#### **Product Change Notification**

1. ECN #: 259866

• LSHM - 0.50MM TERMINAL/SOCKET COMBO

#### 4. Part #'s Affected

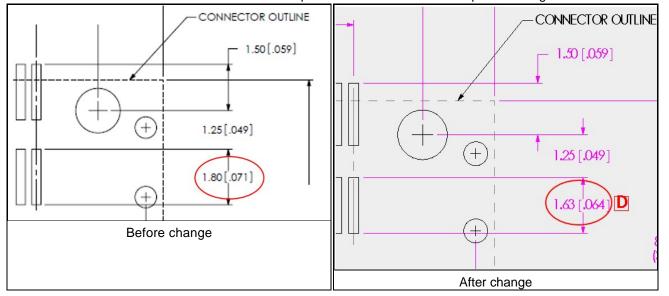
Footprint modified (PCB pads shortened in appropriate area) to optimize overall quality and processability.

Following the recommendation will result in pcb pads (and stencil apertures) with a length of .064" for the row closest to the EDGE OF THE PCB. Location of the pad row as shown on the footprint drawing.

• Form - PCB Pads reduced in length on one row.
